FINAL ENVIRONMENTAL  
IMPACT STATEMENT  
MX: BURIED TRENCH CONSTRUCTION  
AND TEST PROJECT

FINAL ENVIRONMENTAL  
IMPACT STATEMENT  
for the  
MX: BURIED TRENCH CONSTRUCTION  
AND TEST PROJECT  
DEPARTMENT OF THE AIR FORCE

November, 1977

Figure 5. An oblique aerial view of the upper third of the proposed alignment of the long trench, as viewed from the east.

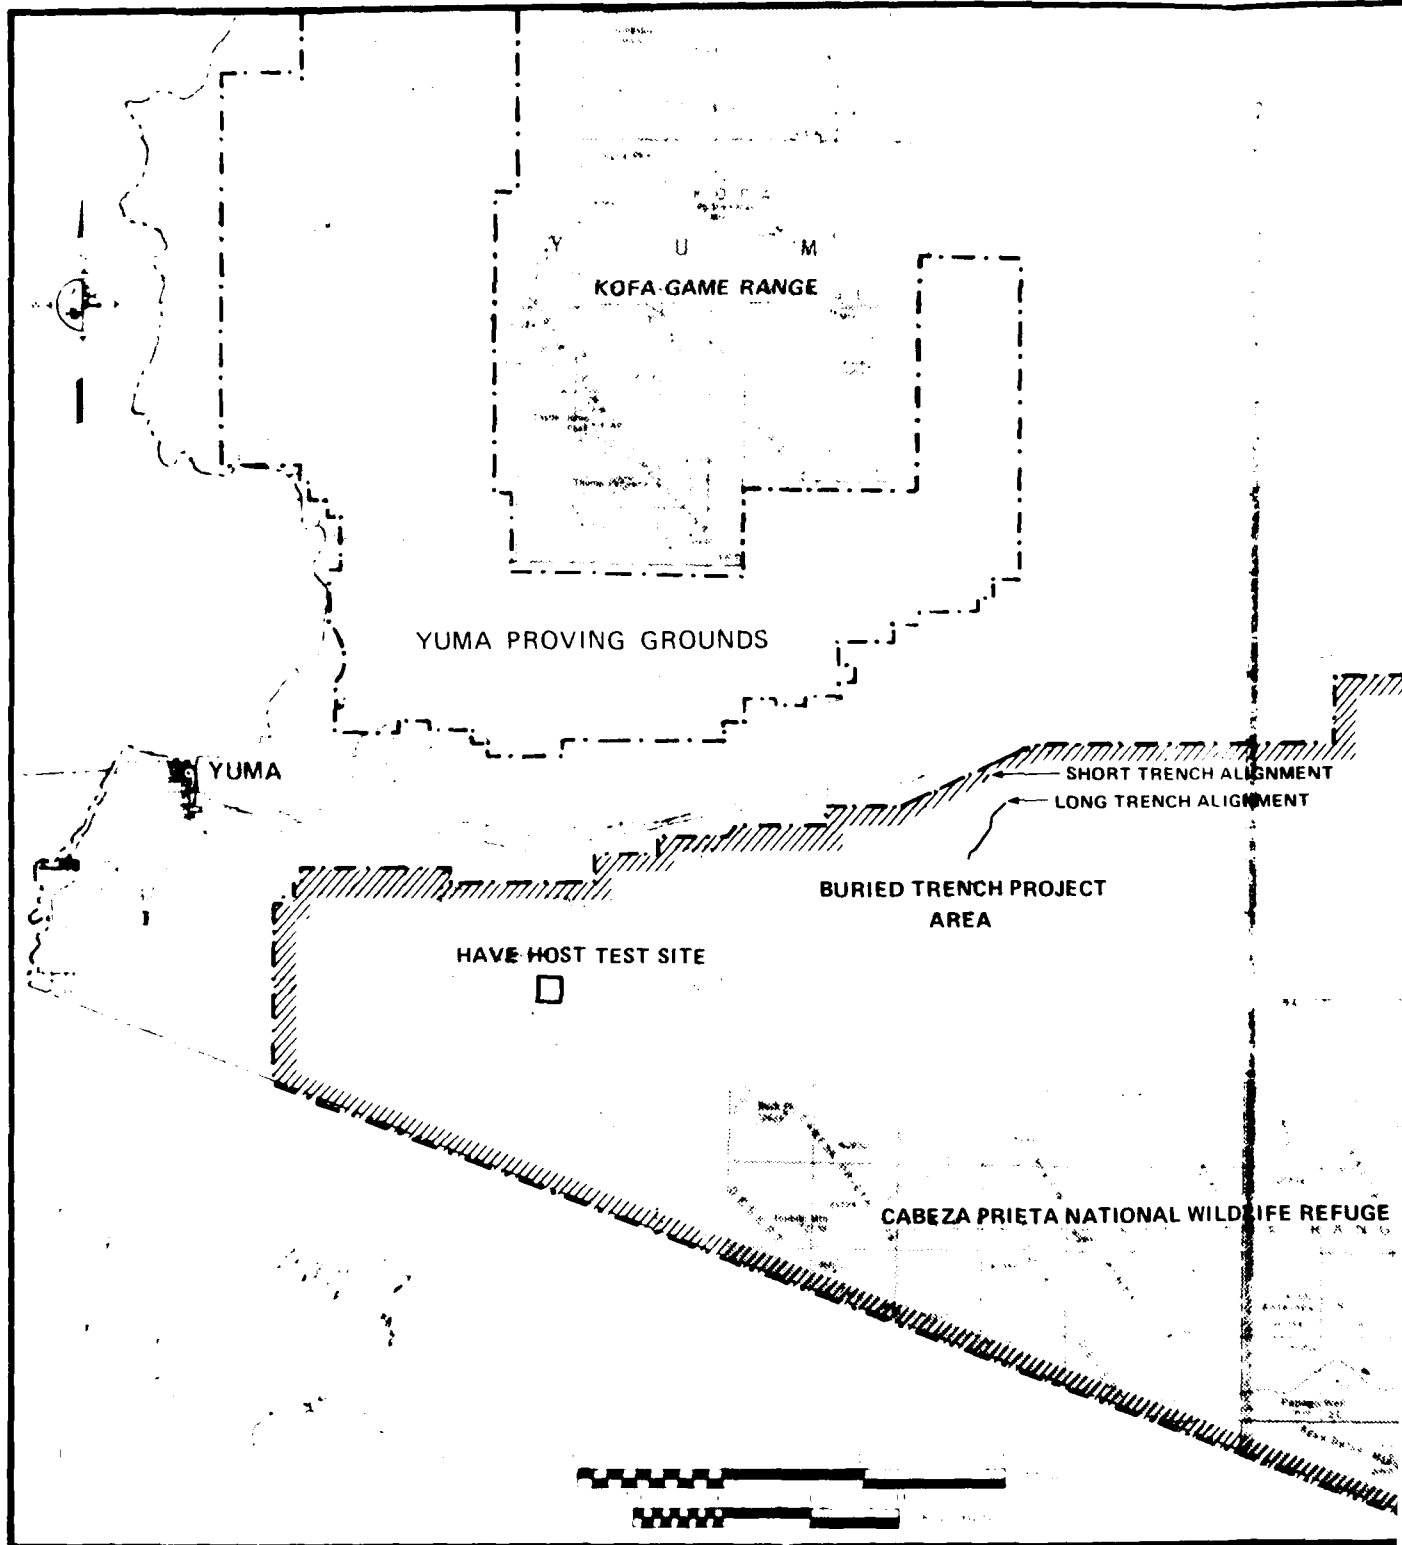
Figures 3 and 5: Should not the "Approximate Alignment of Long Trench" extend to the left edge of Figure 5? Such is indicated by comparison with the Field of View shown on Figure 3.

22. The angle of view shown on Figure 3 for Figure 5 is slightly more acute than it should be.
23. Compaction to 90 percent Proctor density is used to provide adequate support for the buried trench.
24. Care has been taken to minimize crossing of arroyos. All arroyos disturbed by construction will be restored to their preexisting condition when feasible, to prevent blocking of permanent drainage systems (see Sections 3.1.1, and 3.1.2, and 5.4).
25. Where areas of varnished desert pavement are disturbed during construction, the surface layer of rocks will be stockpiled and spread evenly over the surface following backfilling.
26. This has been corrected.

Figure 12. Support facility locations for project construction.

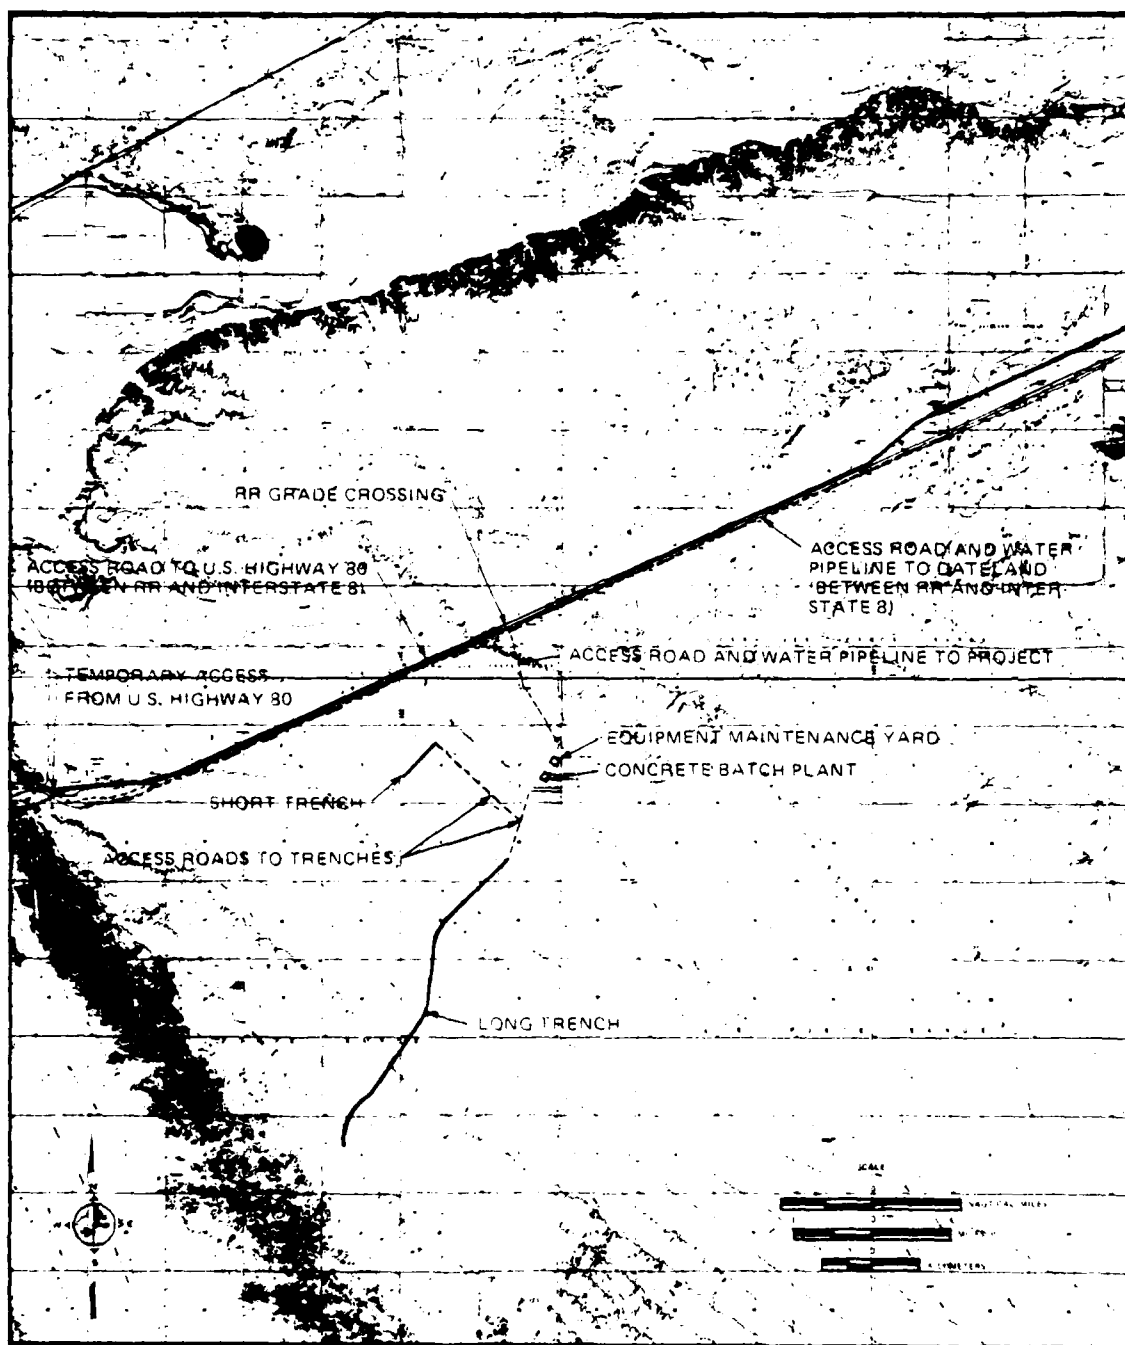
Figure 12, page 17, shows a slip-ramp off Interstate 8 providing  
truck access during construction. To avoid construction traffic  
interfering with interstate traffic, it is suggested that the point  
of access be moved to the east-bound ramp of the Mohawk Interchange  
as indicated on the enclosed diagram. This turnout has good visibility  
in both directions along with being a two-way road.

5. This suggestion has been incorporated in Section 1.1.6.1.

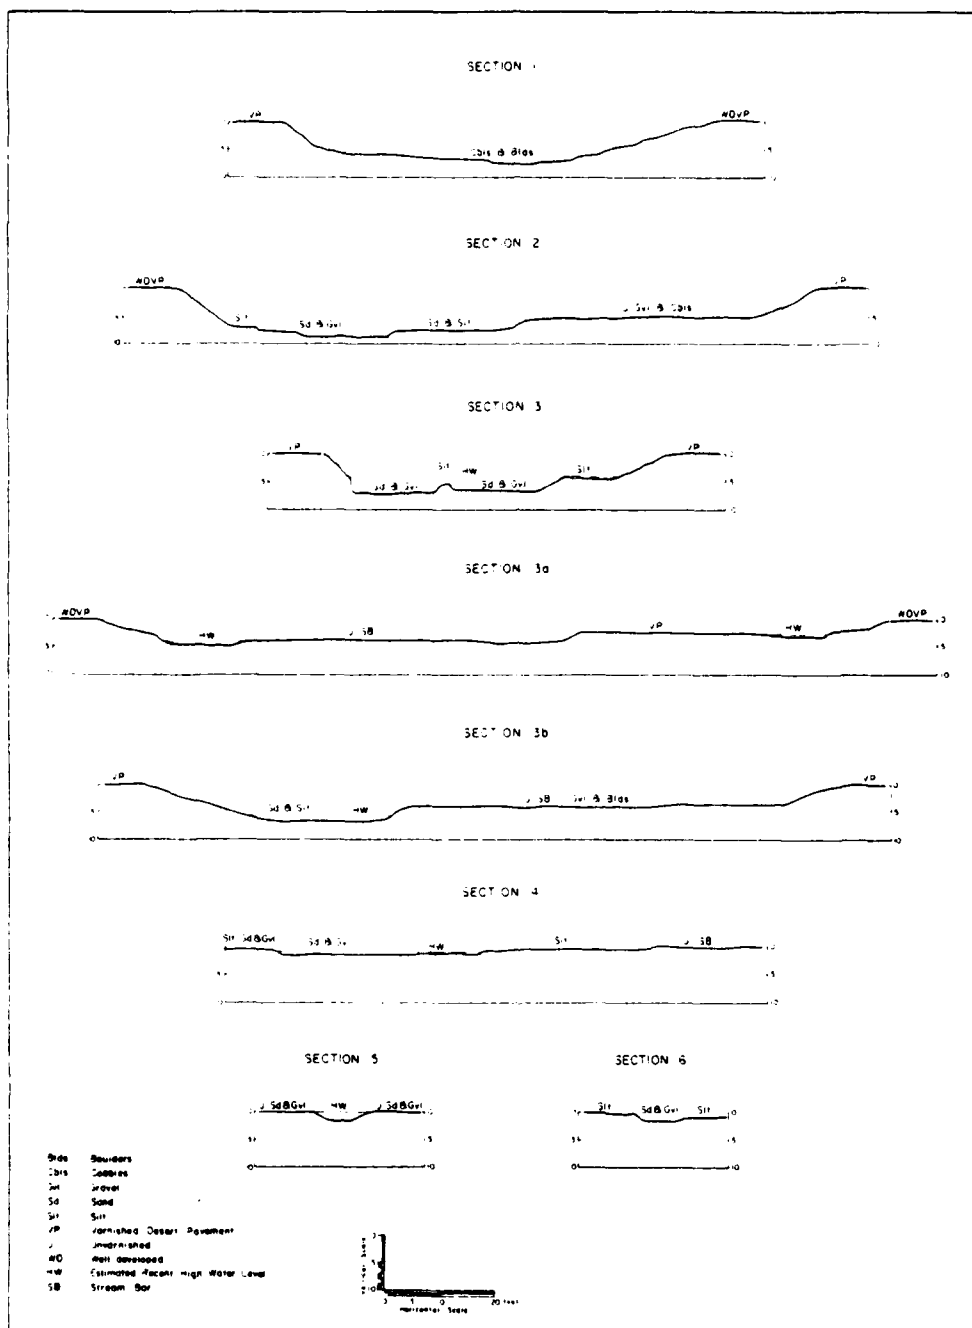
1.1.7.6): Reference should be made to the fact that the alignment has been carefully selected so as to make a minimal impact on arroyos. Figure 14 shows that only three such features are actually traversed by the alignment

However, Figure 14 also depicts near incidence of the alignment (possibly within the 100-m disturbed zone) to several other arroyos at or near measured channel cross sections 2, 3, 3a, 3b, 10, 15, and 19. Plans may have to include modification of the construction use of the proposed disturbed zone so as not to impact the near bank of the adjacent arroyo.
